# City of Fairfax, Virginia

SUBJECT: Discussion on a request of ABTB Mid-Atlantic, LLC to amend the General Development Plan (proffer plan amendment) from retail to a restaurant with drive-through at the Boulevard Marketplace Shopping Center (10140 Fairfax Boulevard)

General Development Plan Amendment (Z-24-00085)  
Special Use Permit (SU-24-00086)

The intent of this post-submission work session request is to receive feedback from the City Council on an amendment to the Zoning and General Development Plan for Boulevard Marketplace Shopping Center in the CR Commercial Retail District and Architectural Control Overlay (ACOD); and a Special Use Permit to allow a restaurant with a drive-through facility. This land use application is subject to a Major Certificate of Appropriateness for architecture and landscaping. The applicant proposes to develop a vacant pad site that is part of the Boulevard Shopping Center to a 2,256 square foot restaurant with a drive-through on approximately 0.66 +/- acres.

Figure 4: Landscape Plan

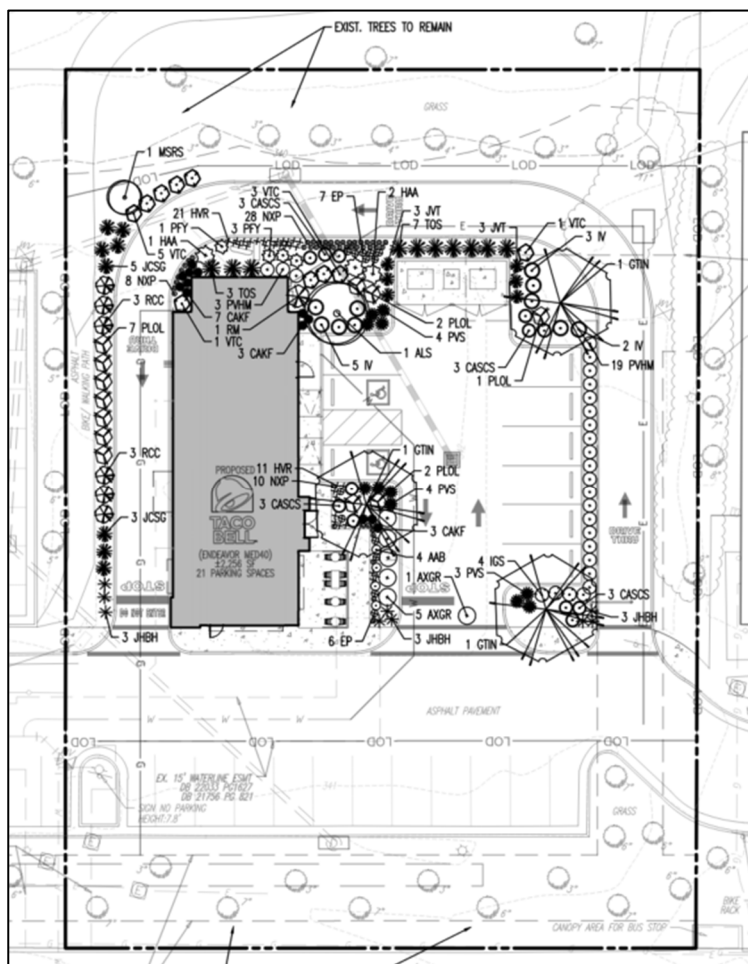
Tree Canopy: The landscape plan as submitted is incomplete. Figure 4 (next page) illustrates the proposed landscape plan for the general development plan.

Figure 5: Drive-Through Facility/Window

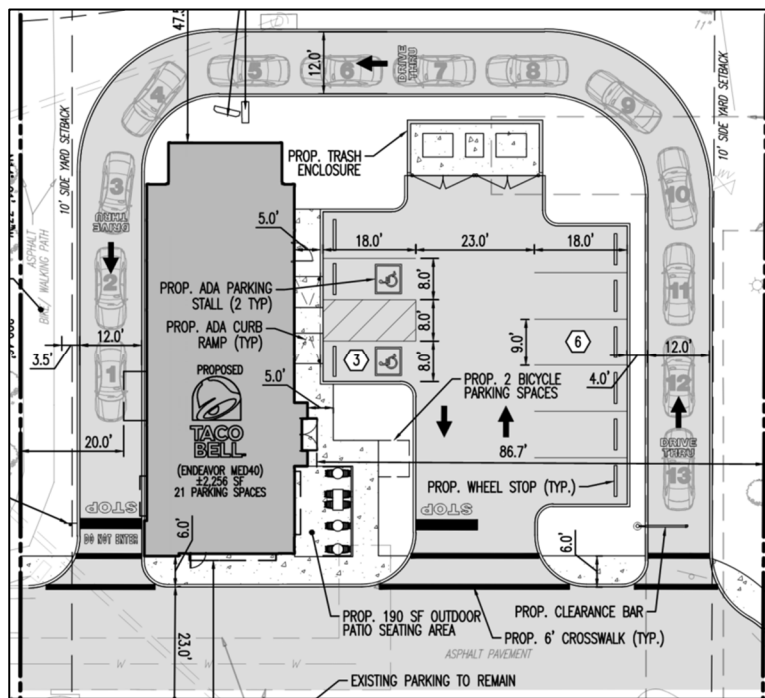
In addition to Section 3.5.5.D.10, the applicant shall demonstrate compliance with stacking space requirements for drive-through windows/facilities (Section 4.2.7 of the Zoning Ordinance). Table 5 (next page) provides the minimum number of stacking spaces:

TITLE: GENERAL DEVELOPMENT PLAN & SPECIAL USE PERMIT PLAN

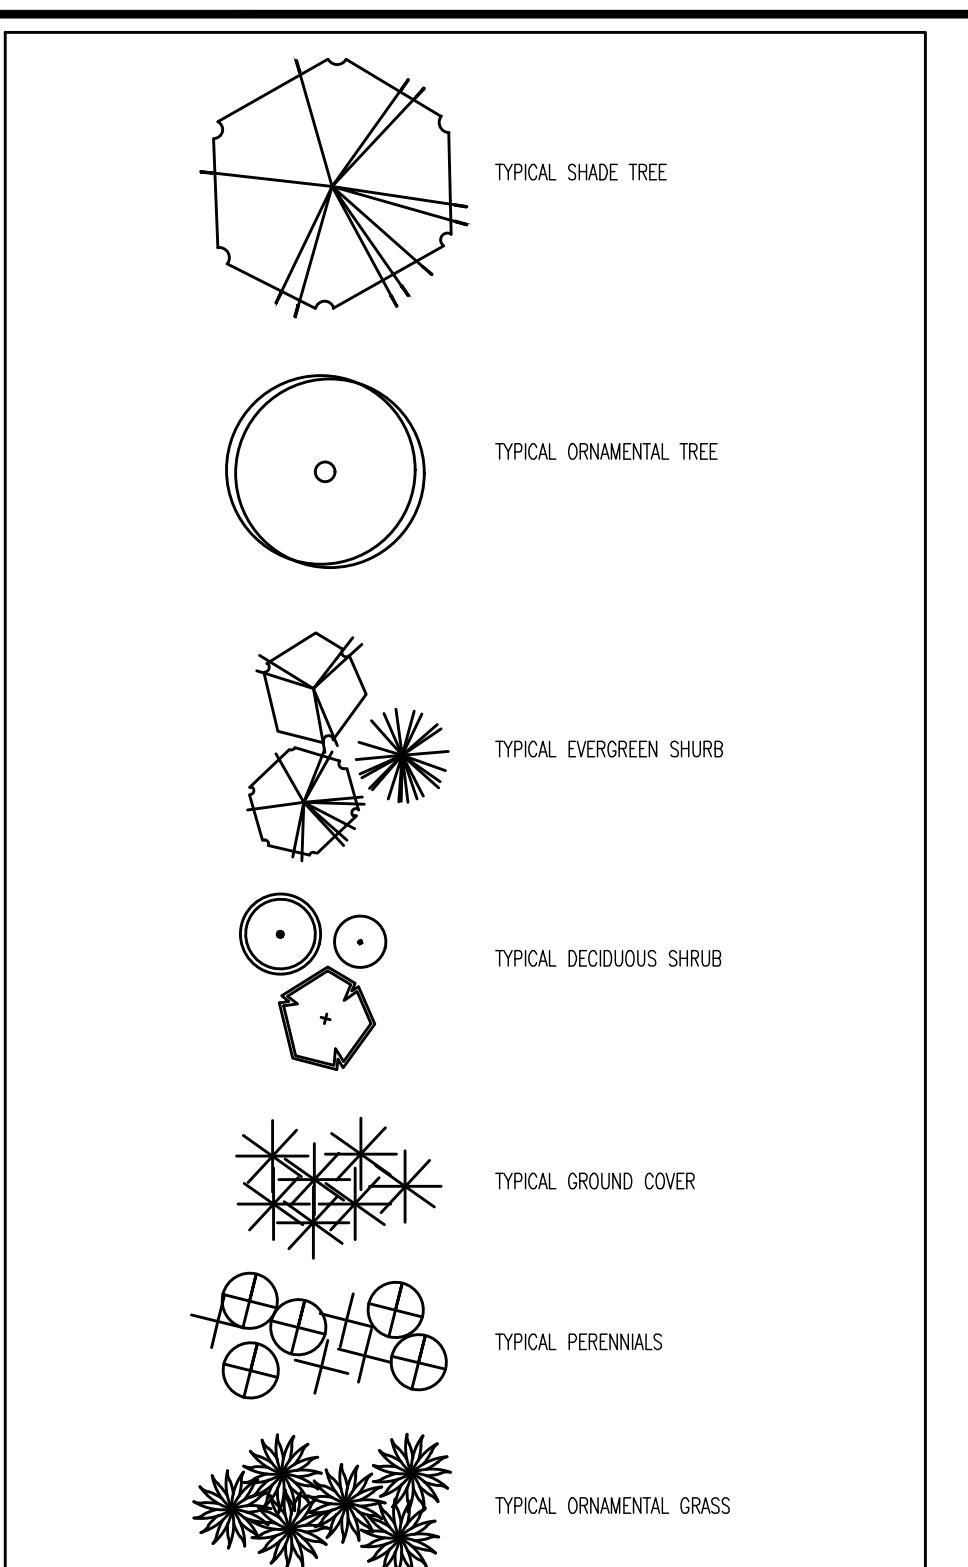
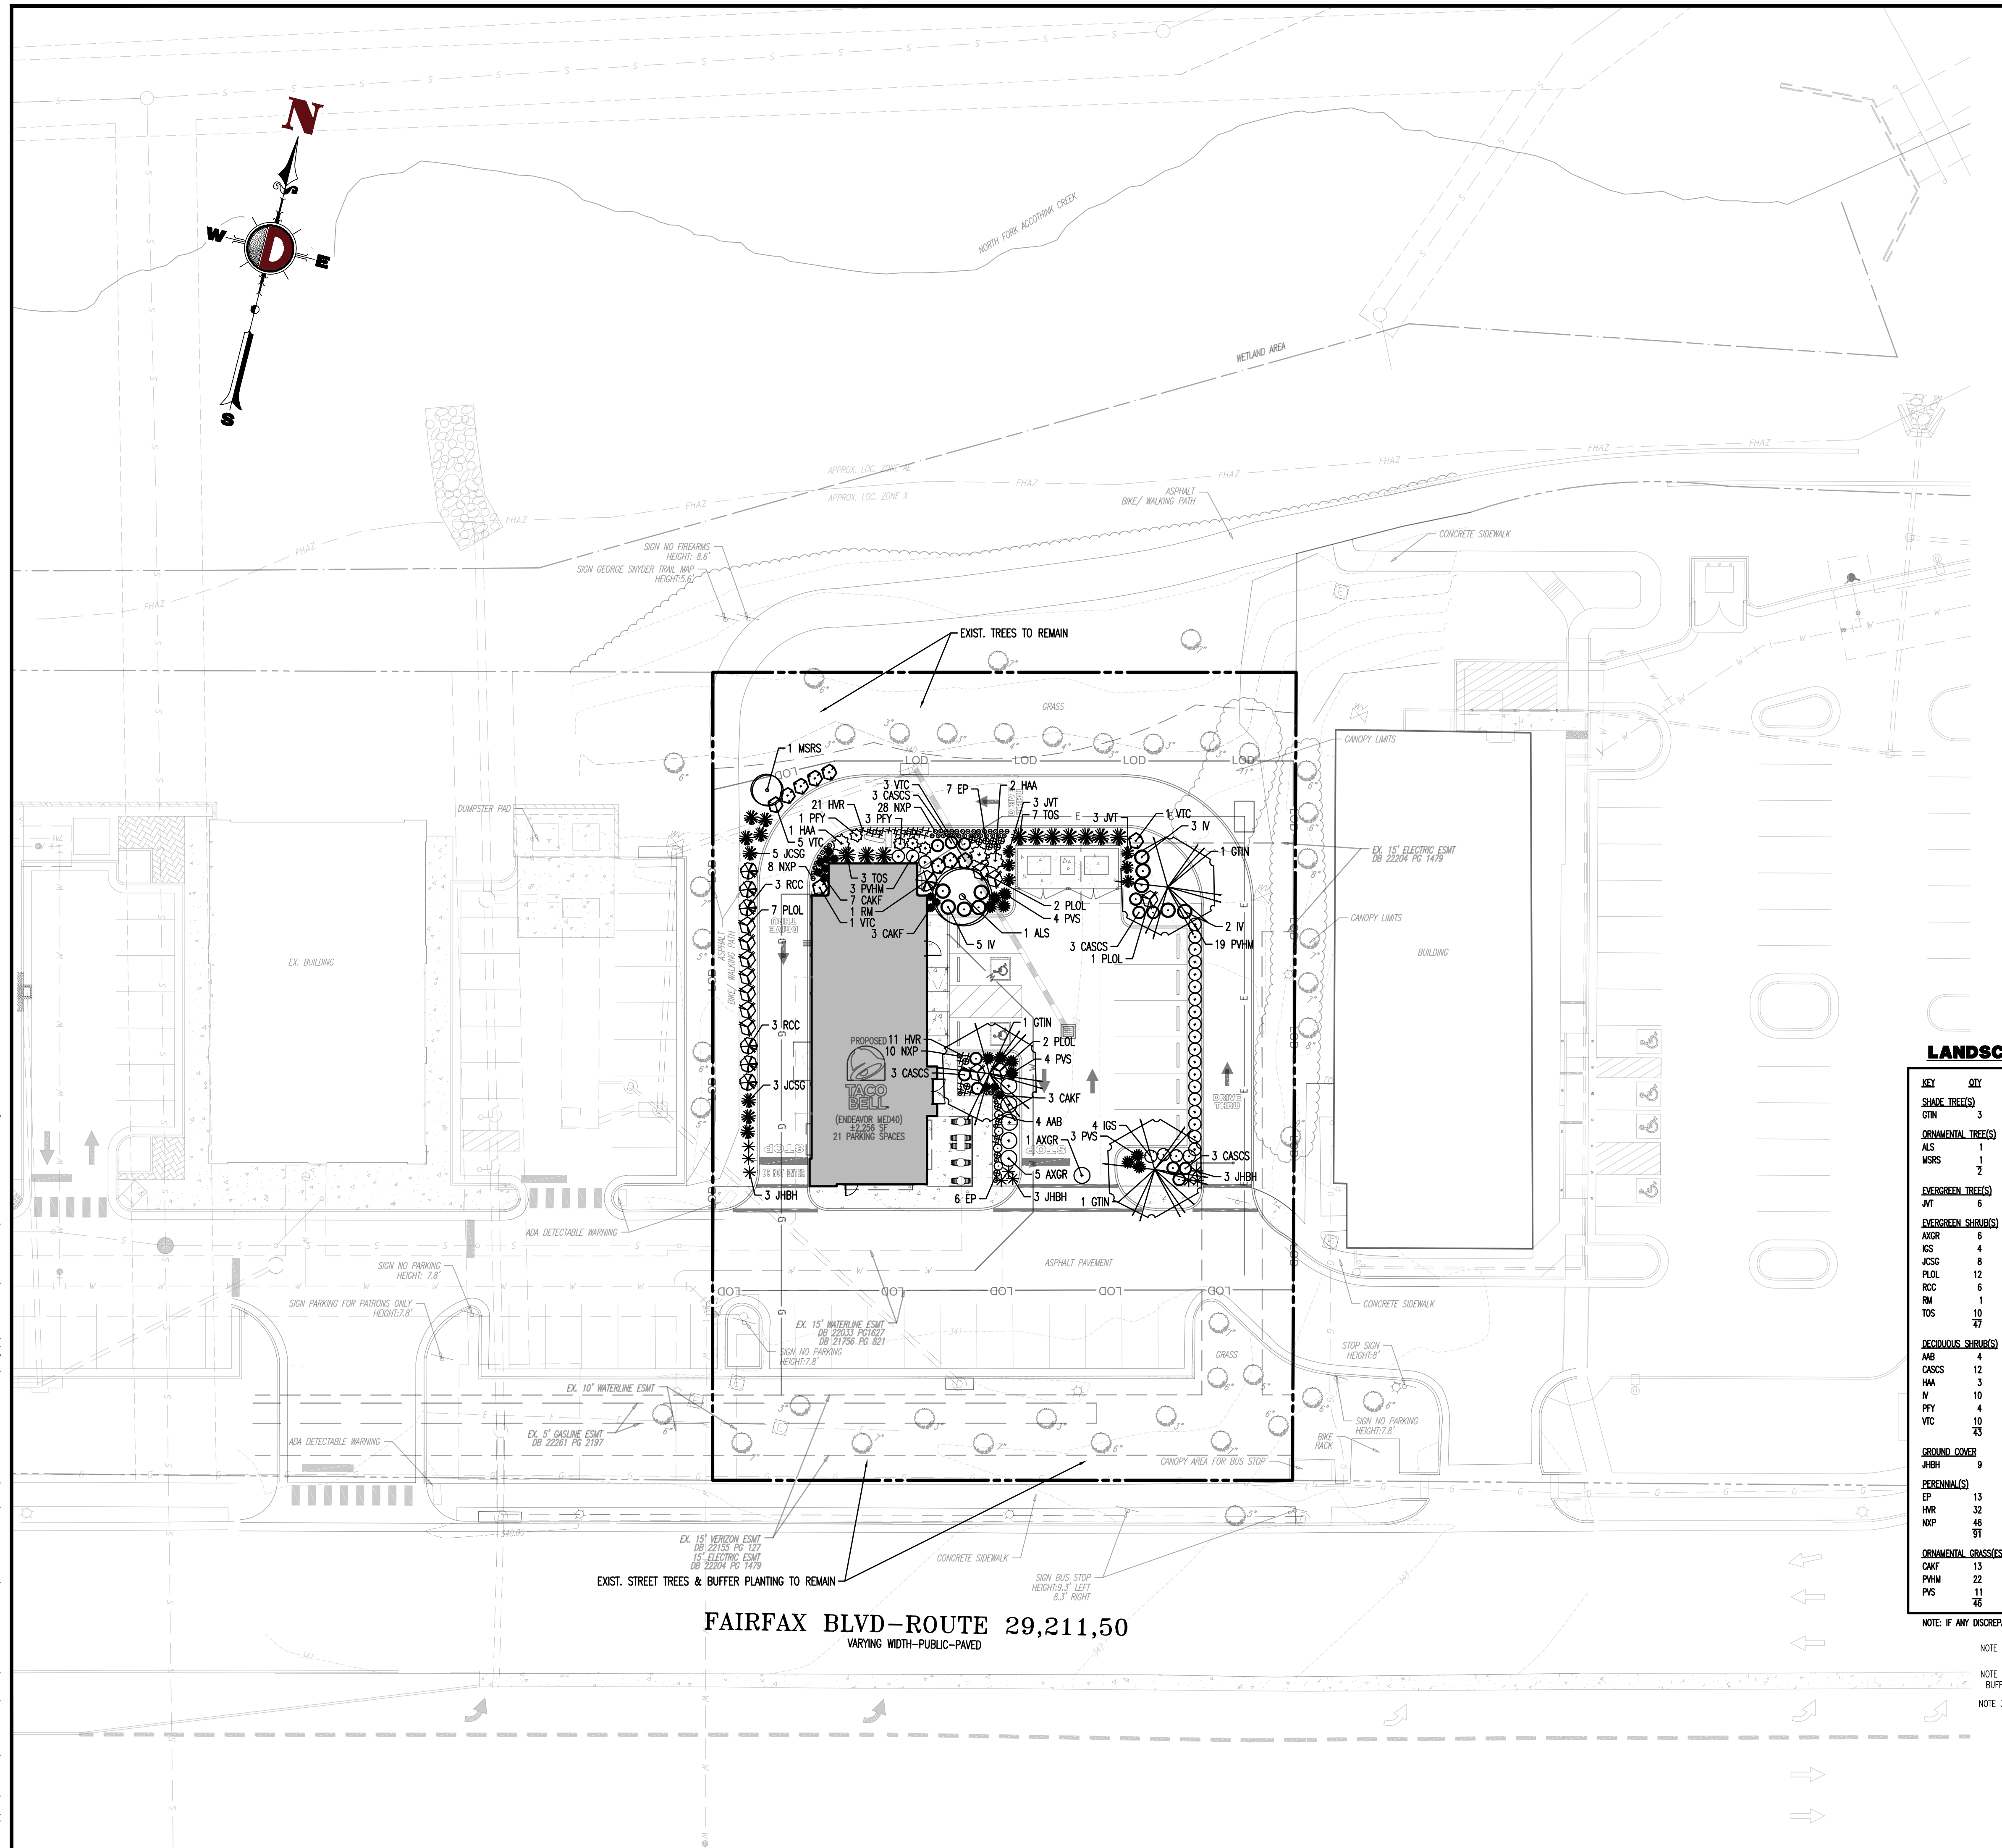
A1. *Provide a table with uses, square footage, and required parking for the overall shopping center including the subject site for Taco Bell.*

**A table and overall plan view for the Boulevard Marketplace Shopping Center ("Shopping Center") has been provided. Please see Sheet 4 of the Revised GDPA/SUP Plat.**
